# *SERVICE BULLETIN*

**MODEL:** VisionAire 5 Oxygen Concentrators

**ISSUE:** Change to VisionAire Main Circuit Board

*Figure 1. Circuit board comparison*

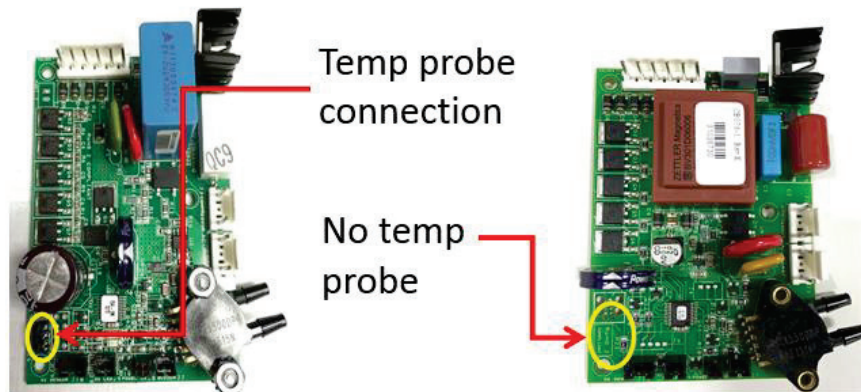
**NOTES:** Effective September, 2017 the VisionAire 5 main circuit board will change entirely from item CB151-1 to CB078-1 (for 115V models) and CB078-2 (for 230V models). CB078 has been used on some 120V models since Sept 1<sup>st</sup>, 2014 and will now be extended to all models of the VisionAire 5.

The updated board will no longer have the temperature sensor probe connection and as a result the 5 beep high temperature alarm will no longer be featured on VisionAire units made with these updated boards. The VisionAire units have a thermal protection switch attached to the compressor stator that will shut down the compressor in the event the compressor overheats (this switch activates at 145°C). For these newer units, the overheating condition will cause this thermal switch to shut down the compressor, which results in low system pressure and the 3 beep low pressure alarm.

CB078 circuit boards may be used for all service parts and can be retrofitted into VisionAire 5 models that were originally built with CB151 or CB102 circuit boards. CB151 or CB102 boards should not be installed in units designed to use CB078, as the unit will need an additional temperature sensor and may not meet RoHS 2 or electromagnetic interference compliance if older boards are used. CB151 boards can still be used in units that were originally equipped with CB102 or CB151 boards (while supplies last).

*Figure 2. CB151 or CB102 style circuit board*

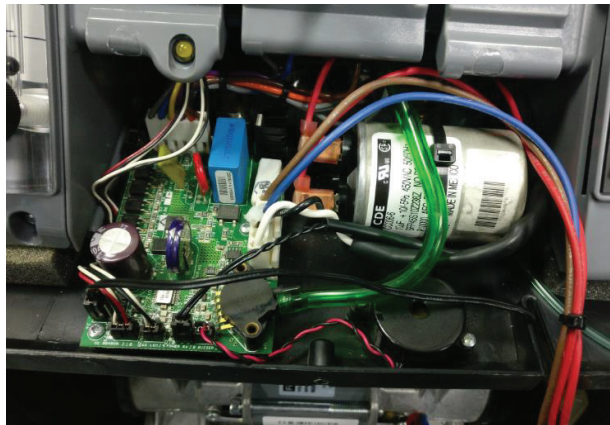
Step 3: Disconnect the pressure sensor tube and all wires connecting the circuit board except the valve wire harness. Remove and discard the temperature probe (may require removing the compressor enclosure cover).

*Figure 5. Valve wire harness connected*

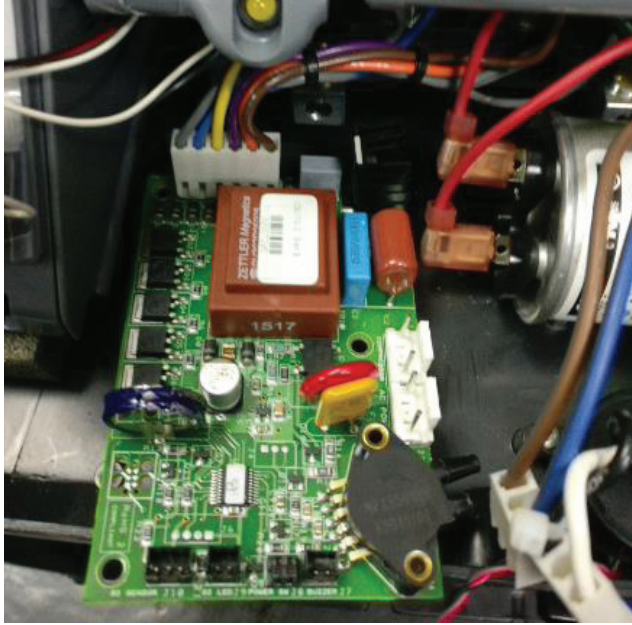
Step 5: Connect replacement circuit board to the valve wire harness.

*Figure 6. Screws re-installed*

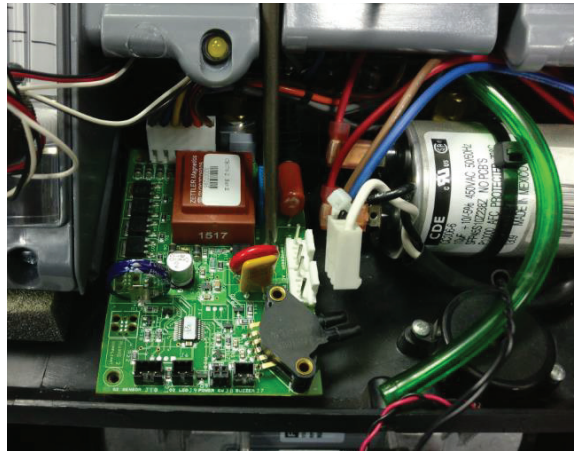
Step 6: Reinstall the three circuit board screws
